ADDENDUM NO. 1

TO: PLANS AND SPECIFICATIONS FOR STATE OF MISSOURI

**Renovate Lobby and Restrooms 1st and 2nd Floor
Howerton State office Building
Jefferson City, Missouri
PROJECT NO.: O2339-01**

SHEET TITLE:
FIRST FLOOR
LOBBY
RENOVATION PLAN

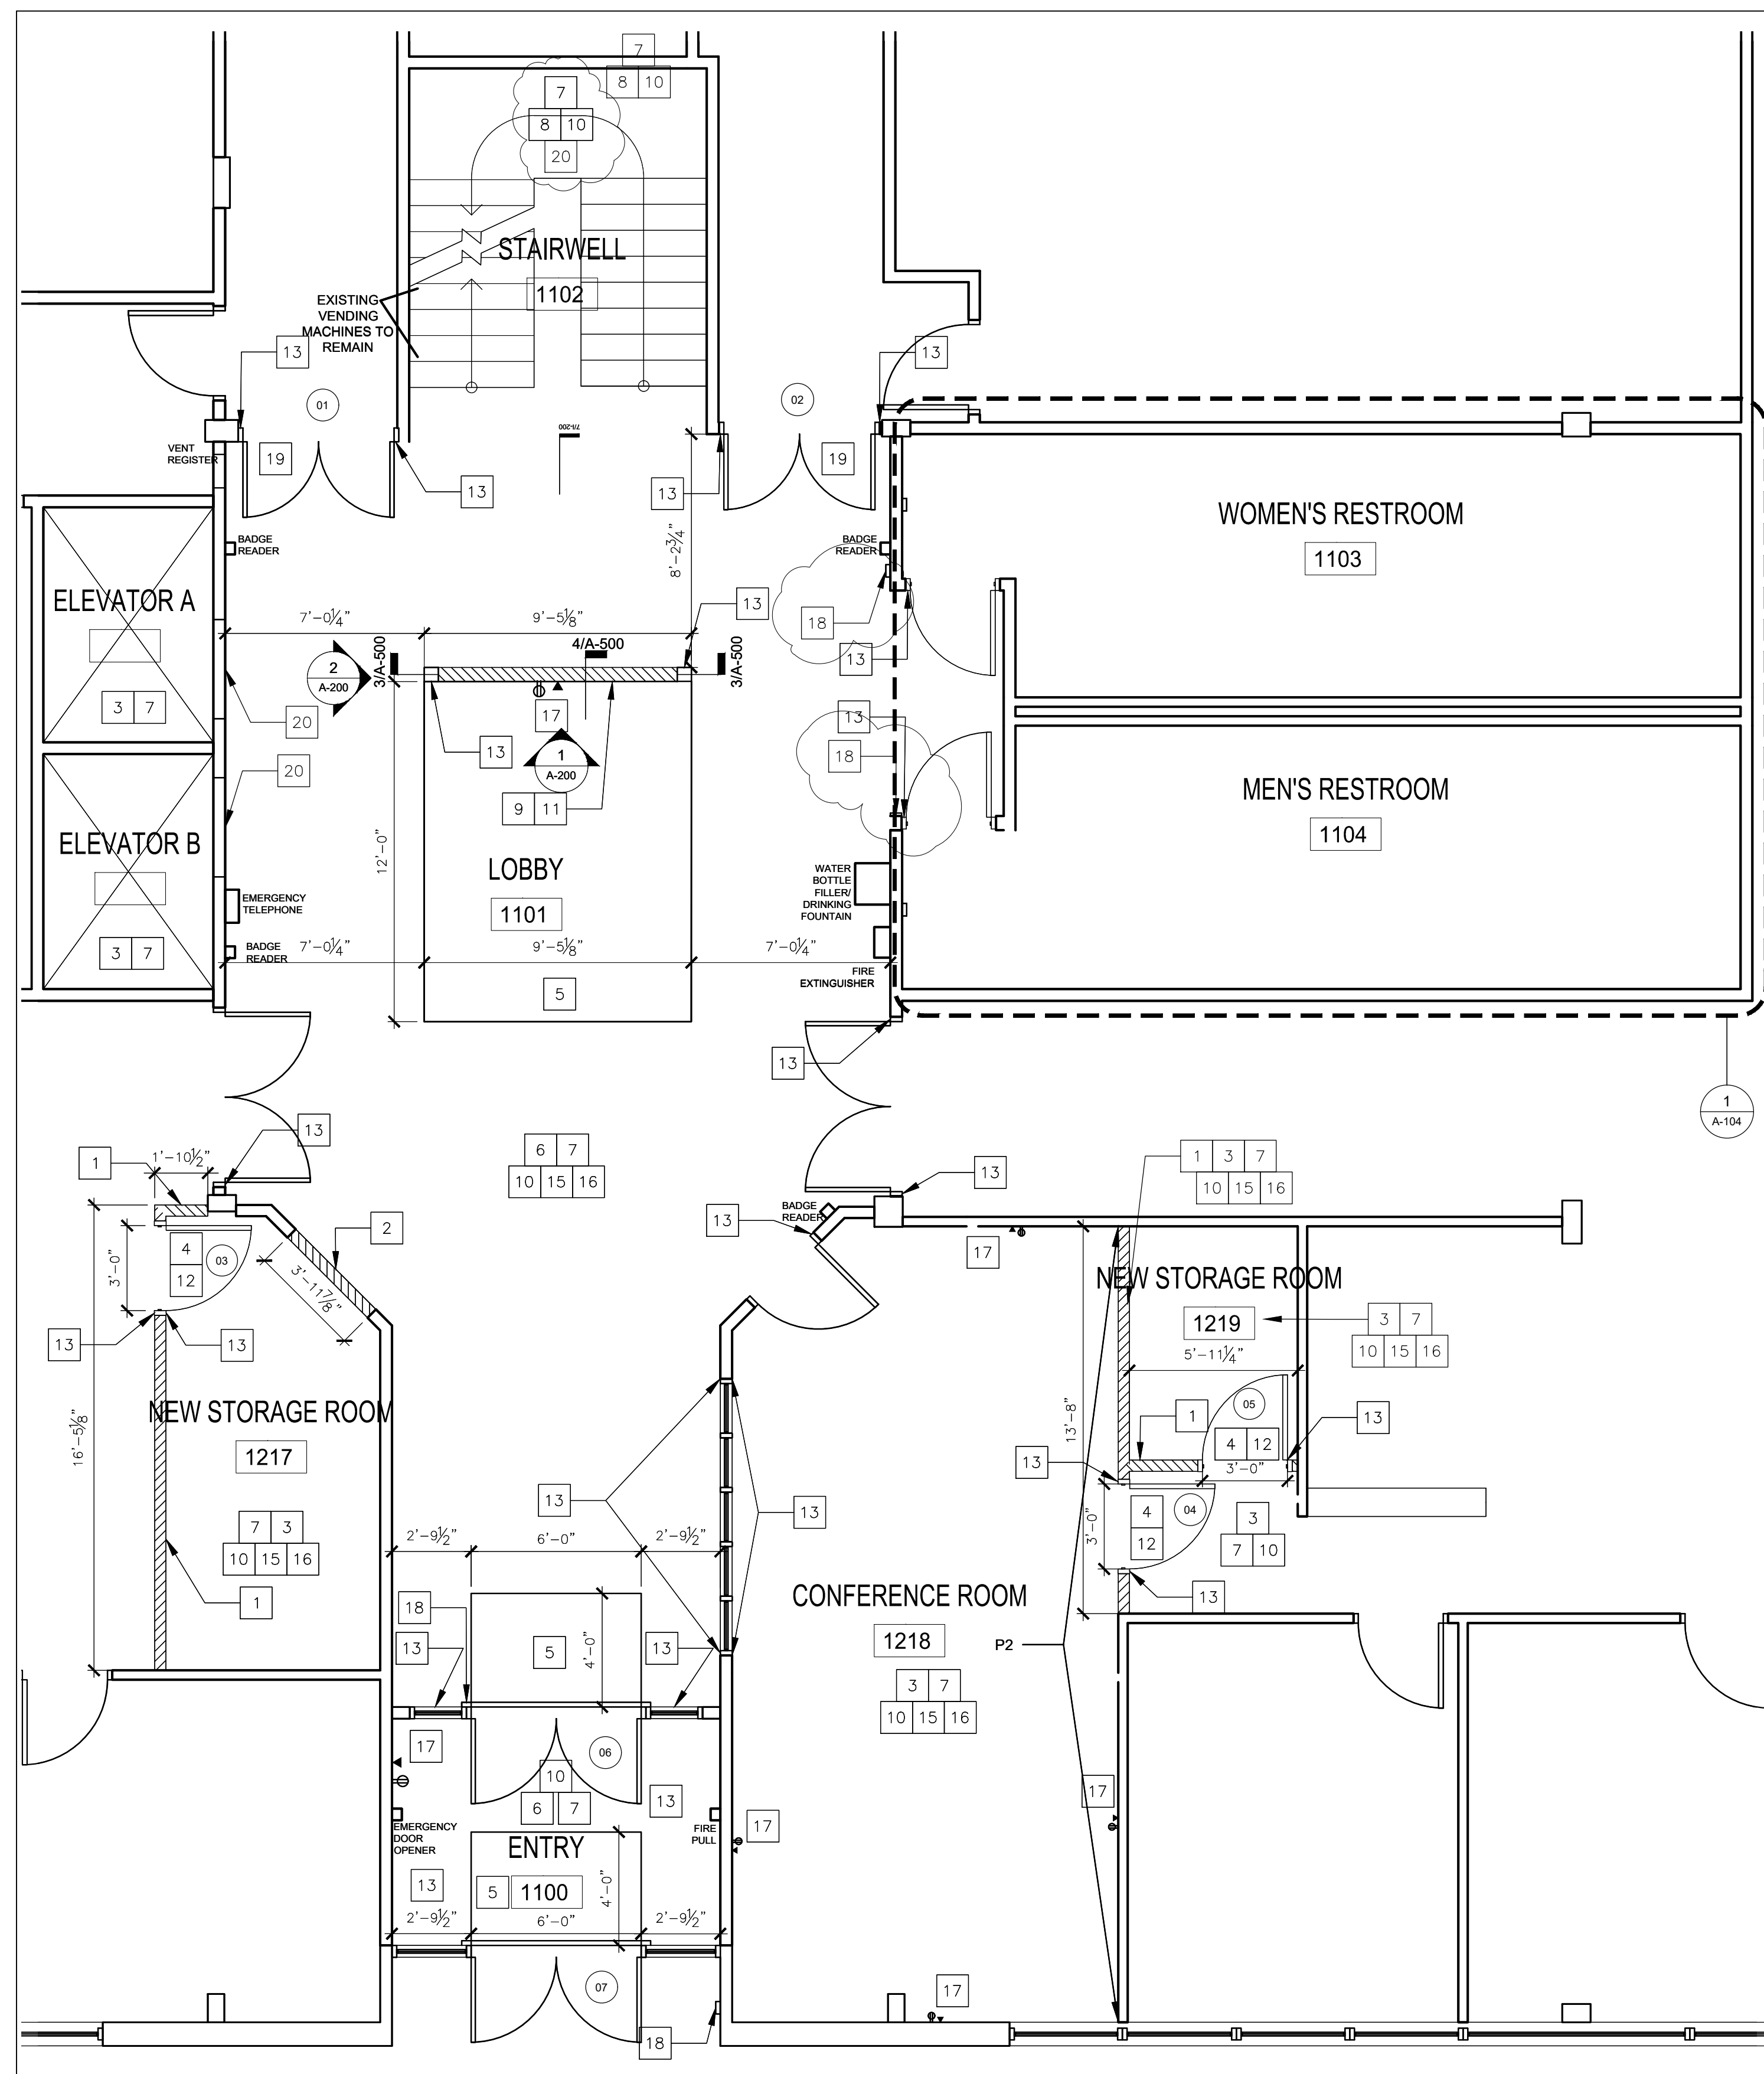
A-102

1. Wall Symbol Key. Change demountable walls (existing base trim to be reused) to new walls. Removed change fixed gypsum metal studded walls (vinyl base cove to be replaced).
2. Finish Specifications. B1 color changed to Fudge 167.
3. Room Finish Schedule. 1218 Conference room – Paint P1/P2. – Flooring C1. –

Wall Base B1.

4. Drawing 1 – First Floor Renovation Plan in stairwell 1102 Keyed Note “13” changed to keyed Note “20.”
5. Drawing 1 – First Floor Renovation Plan near restrooms 1103 and 1104 Keyed Notes “17” changed to keyed Note “18.”
6. Revised Plan Tag Notes: Keyed Note “13” Paint door frame to match building standard changed to Paint door frame, window trim and mullions to match building standard.
7. Revised Plan Tag Notes: Keyed Note “20” Paint elevator doors and trim, window trim and mullions, door frames, steel tubing, stair railing and vent registers. (P3) Changed to Paint elevator doors and trim, steel tubing, stair railing, and vent registers. (P3)

SHEET TITLE:
**SECOND FLOOR
LOBBY
RENOVATION PLAN**

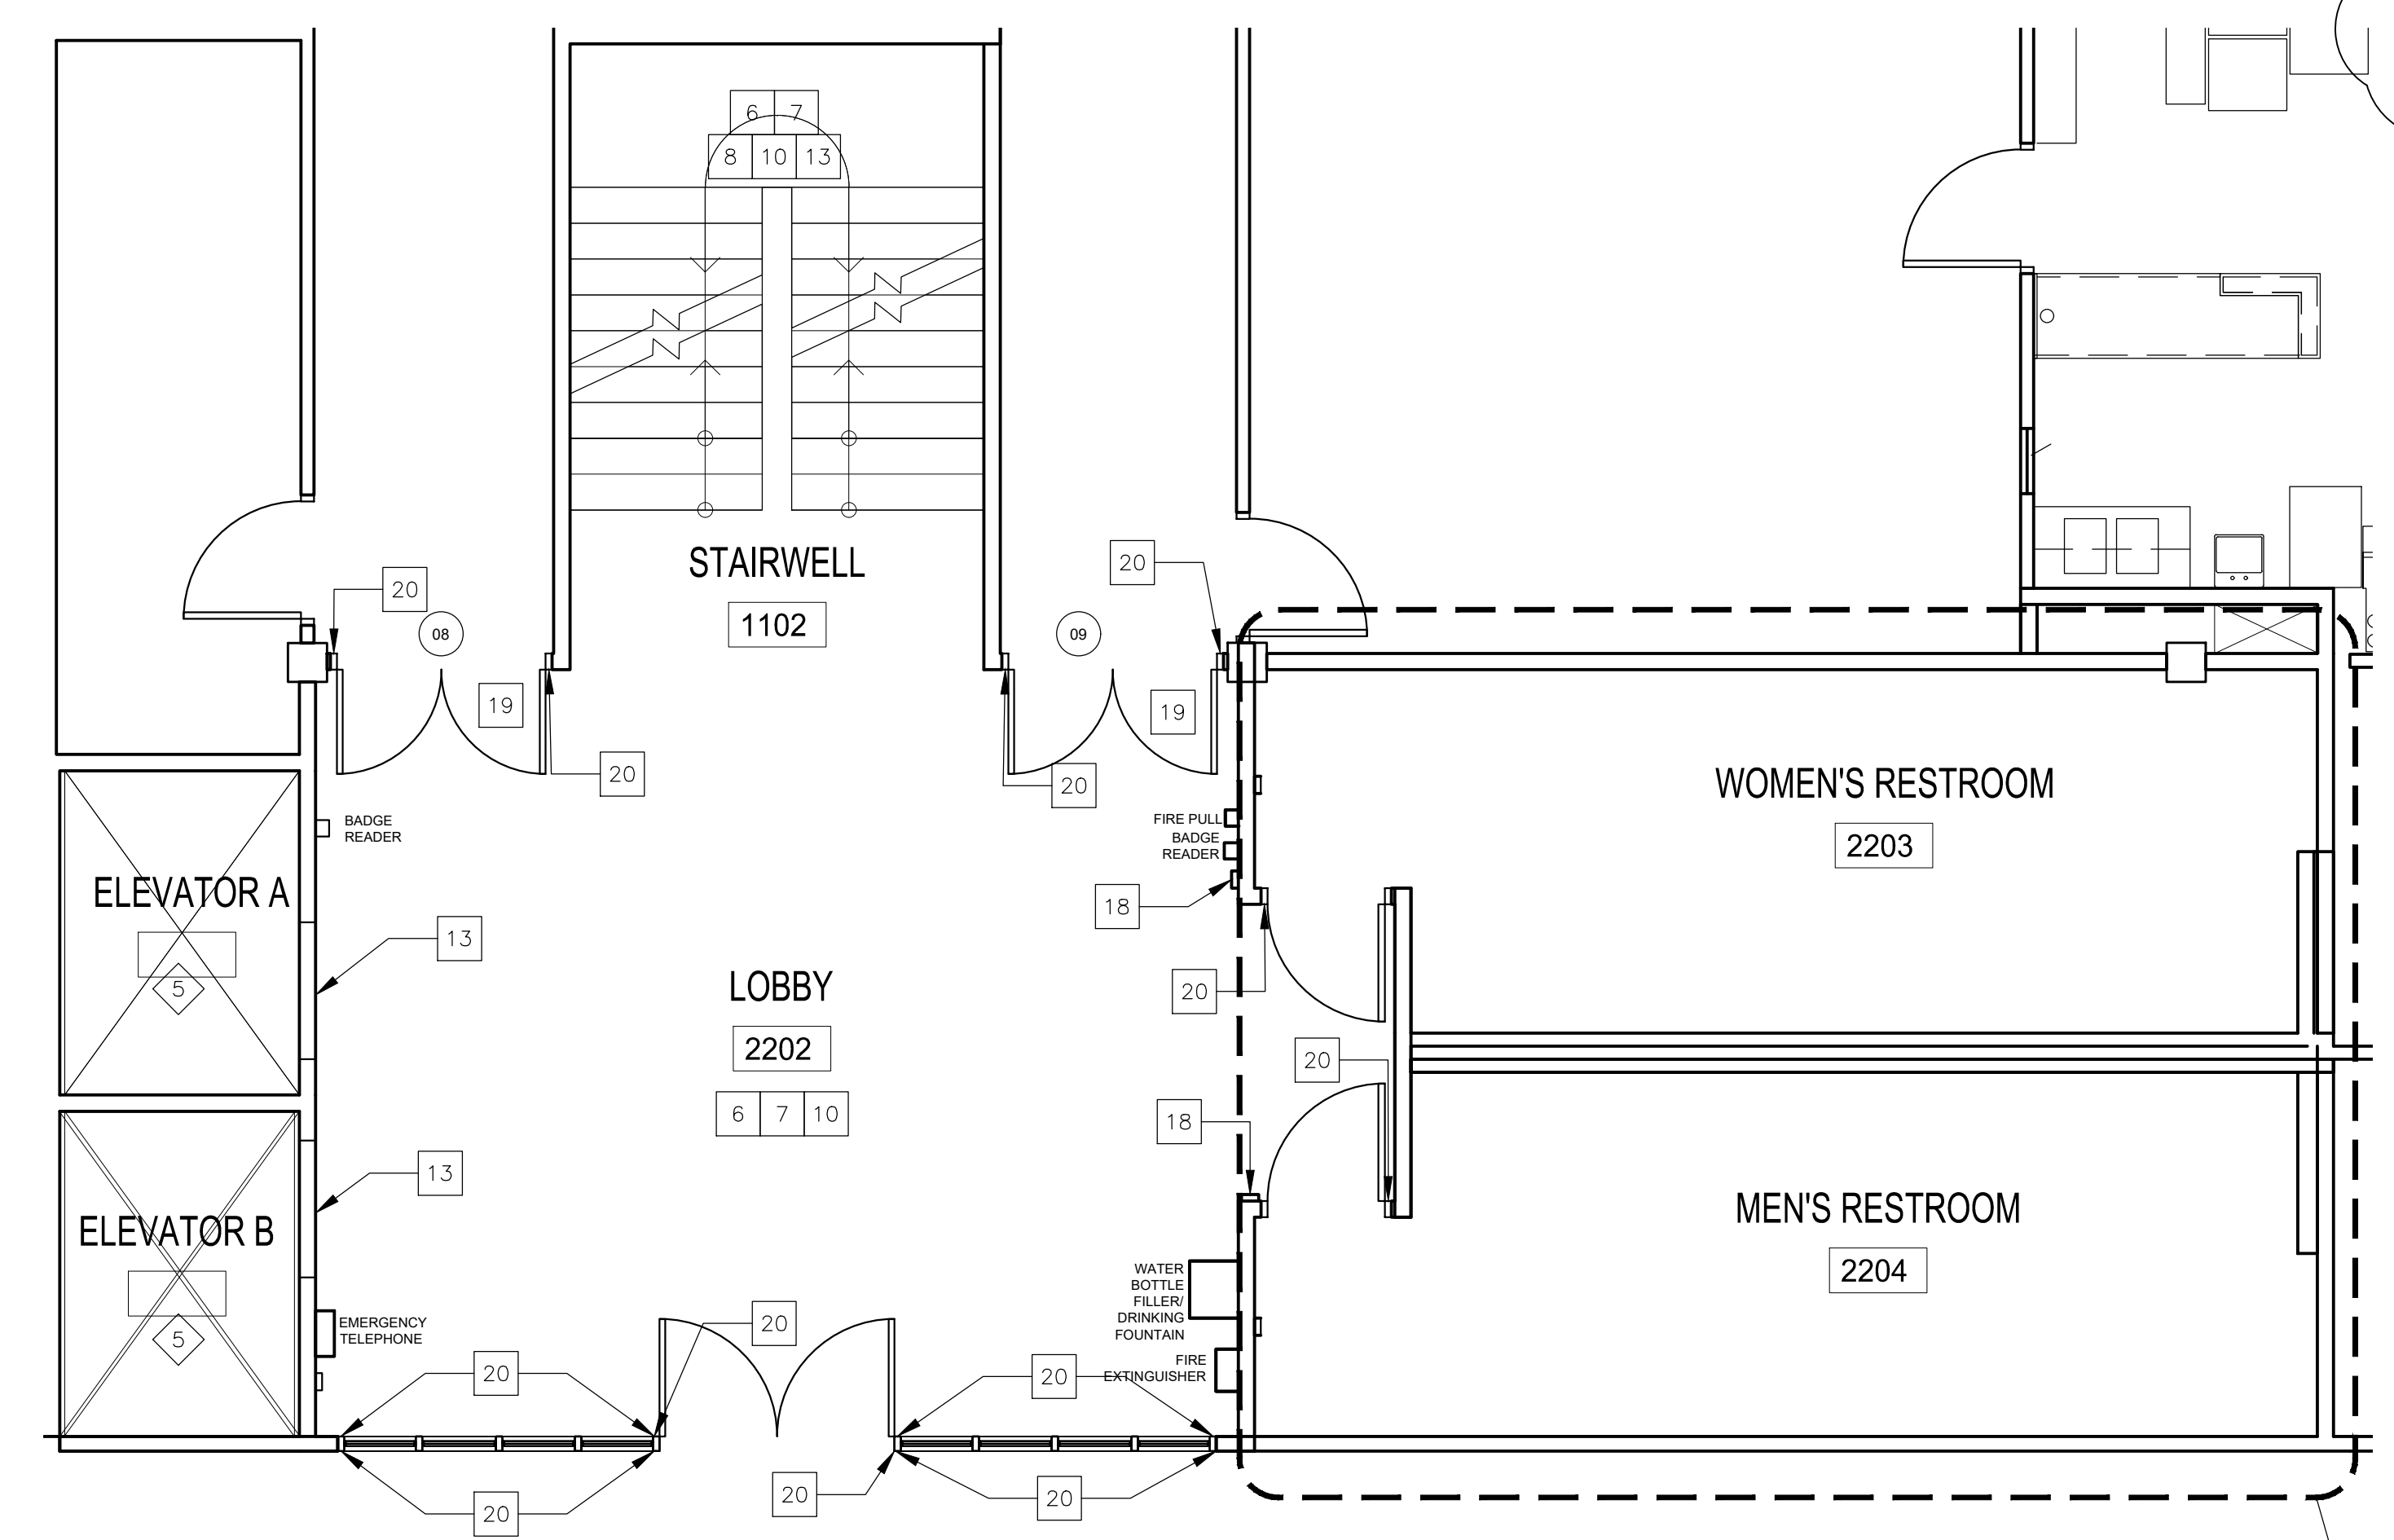
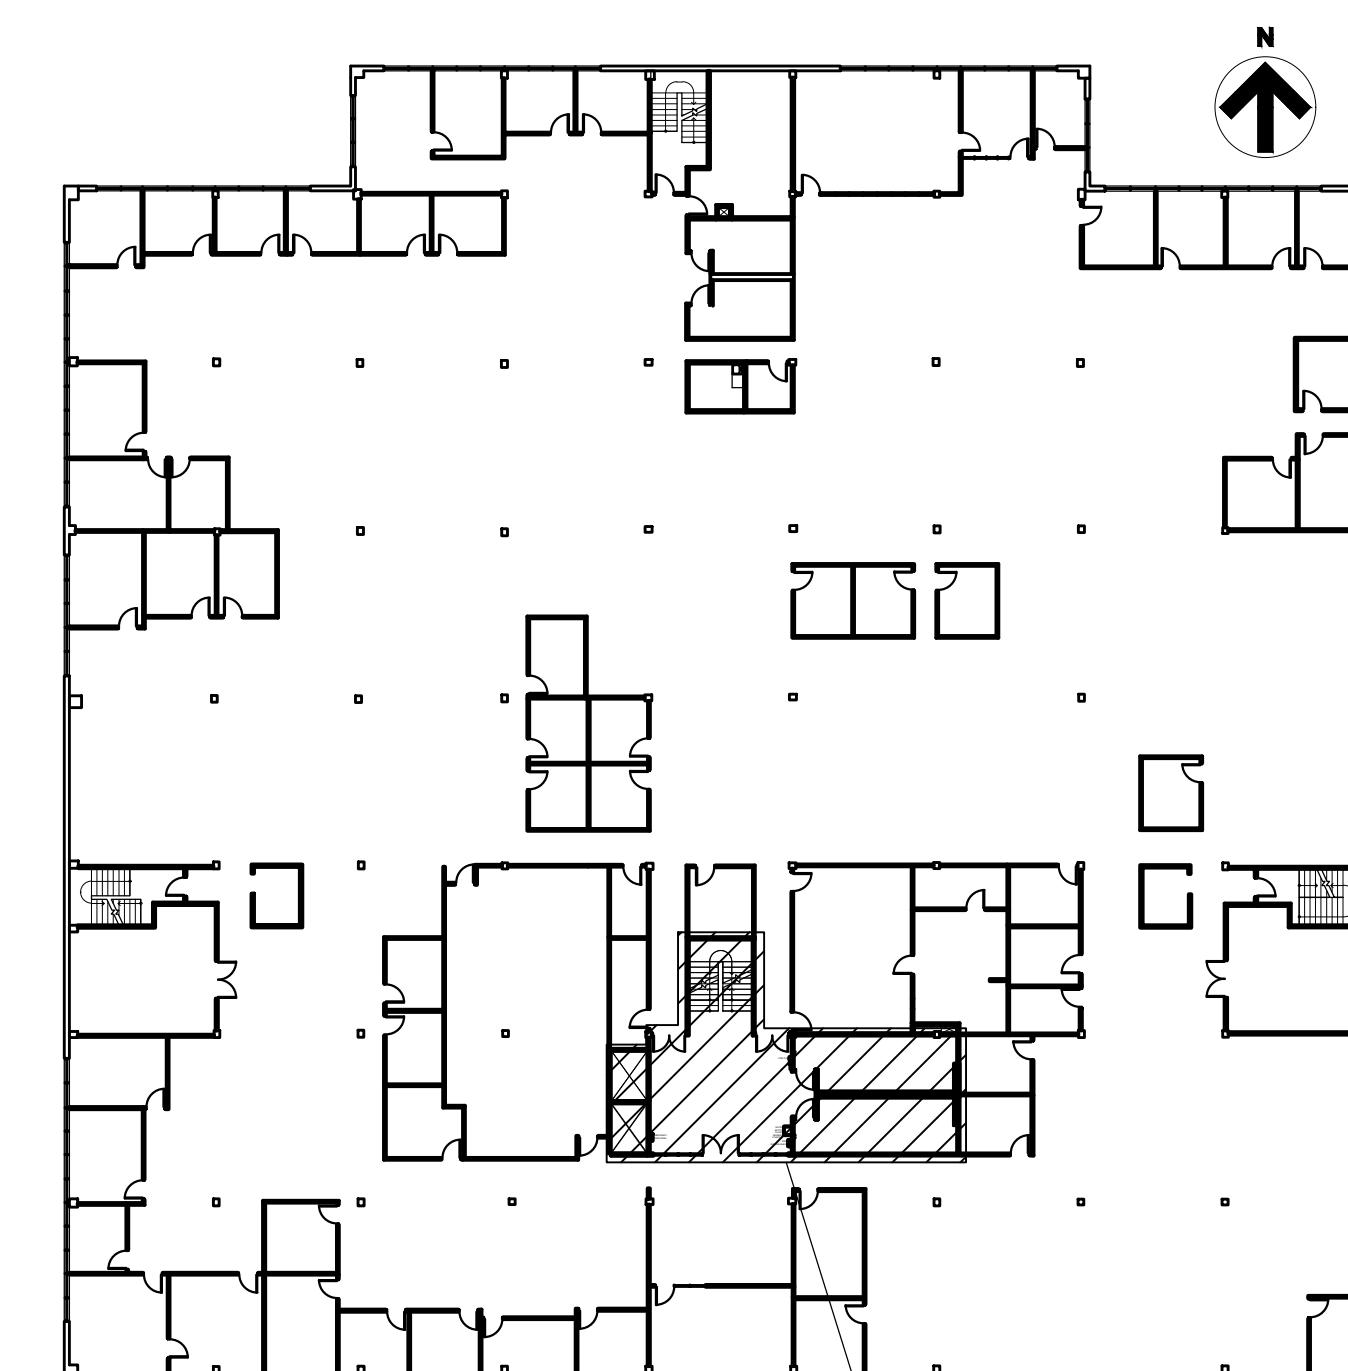
A-103

1. Wall Symbol Key. Change demountable walls (existing base trim to be reused) to new walls. Removed fixed gypsum metal studded walls (vinyl base cove to be replaced).
2. Room Finish Schedule. Removed C1 flooring from 2202 Lobby.
3. Revised Plan Tag Notes: Keyed Note “13” removed window trim and mullions, door frames.
4. Revised Plan Tag Notes: Keyed Note “20” added window trim and mullions.
